Grimes City Council Agenda

Grimes City Council Meeting October 11, 2022
In Person/Zoom at Grimes Community Center, 410 SE Main Street

1. Brookside Village – Preliminary Plat
2. Rock Creek – Preliminary Plat 1
3. Rock Creek Building – Site Plan
4. Ordinance 771 Adopting New Dog and Cat Licensing, and Control of Dogs
    a. Public Hearing Adopting New Dog and Cat Licensing and Control of Dogs
    b. First Reading of Ordinance 771 Adopting New Dog and Cat Licensing, and Control of Dogs

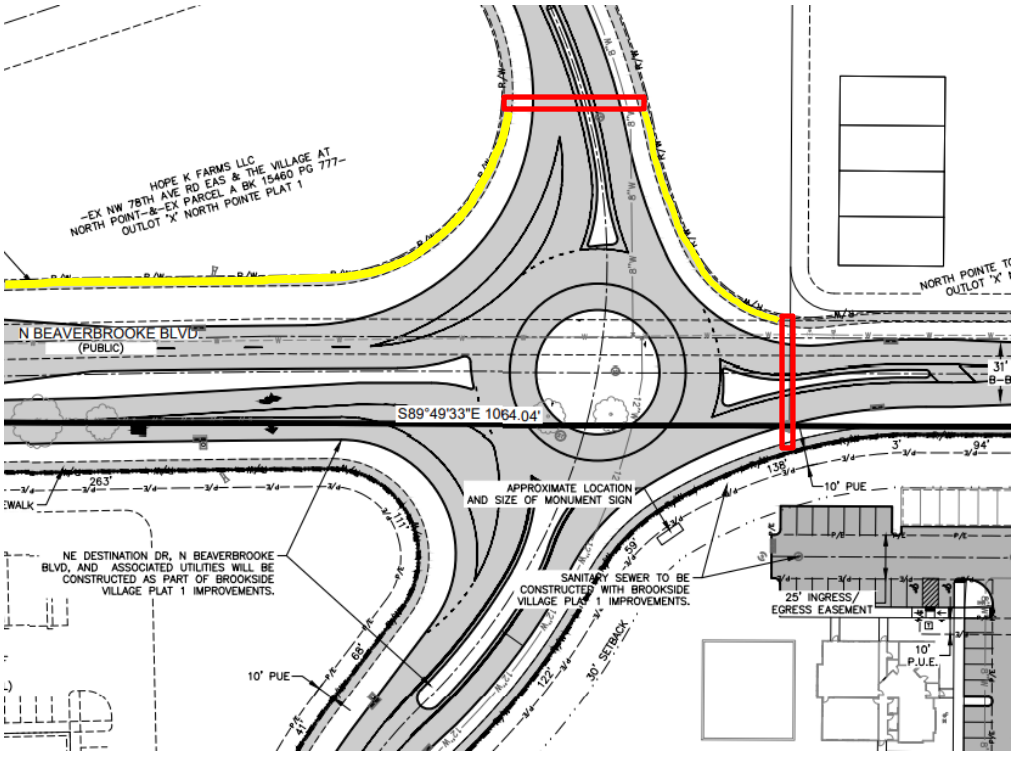
7. ~~Please show 8' trail crossings on the roundabout to match the below image. These will be connected to the 8' trail. Please change the northwest 5' sidewalk to an 8' trail – and the connection between crosswalks to the northeast as an 8' trail (both in yellow). These north trails/sidewalks will be installed by whoever develops to the north. This project will just have to make sure there are 8' crosswalks cuts.~~

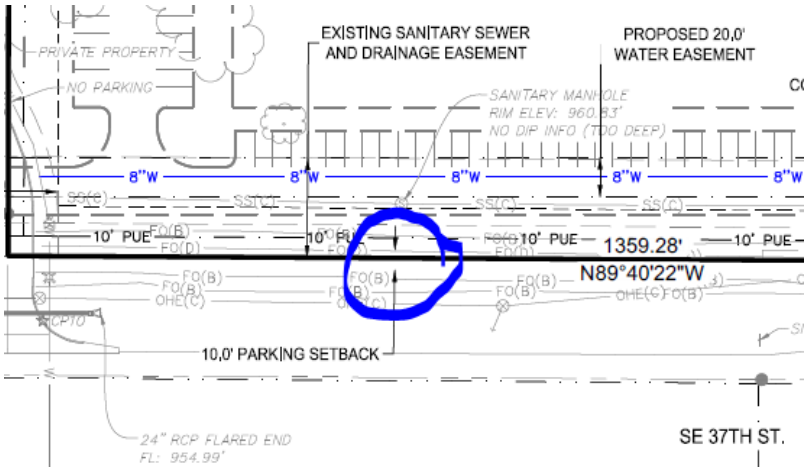
1. ~~Revise the 10' parking setback label along SE 37th St. It is shifted south too far. The label was not shifted. Please fix. Please change the label from 15' parking setback to 10' parking setback. The parking setback line and remain where it is.~~

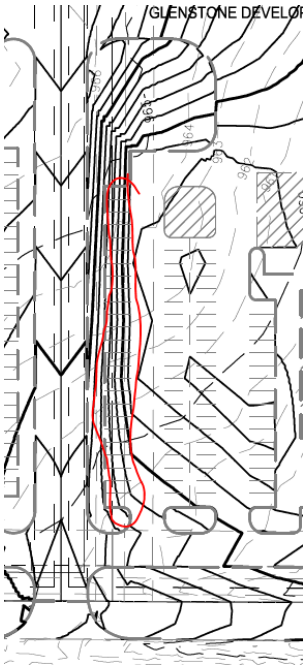
1. ~~Please also provide a 37' typical section.~~

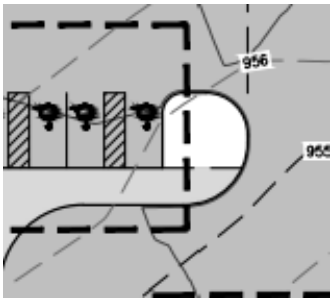
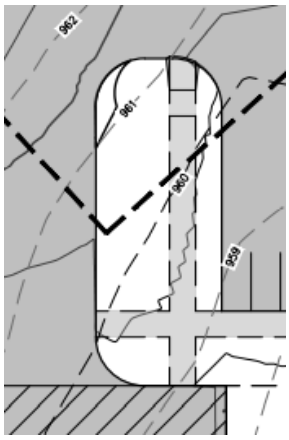
8. ~~How will the sidewalks tie into the pavement? Label spot elevations. Are ramps required? If so, provide ramps details.~~

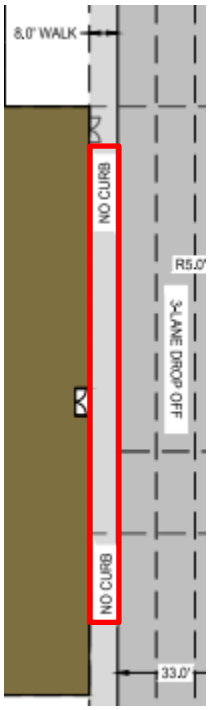
4. ~~Clearly label transition from full curb to no curb along the drop off lanes. Does the pavement come up or the sidewalk drop down? Please clarify where the curb stops. Is there no curb between the two labels?~~

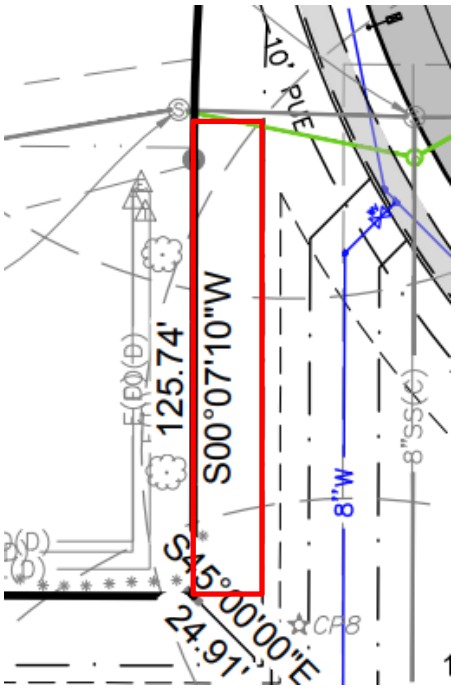
6. Provide 5' buffer of evergreen trees along the townhome property to the northwest. These plantings need to be shown and installed with the site plan improvements. Please add.
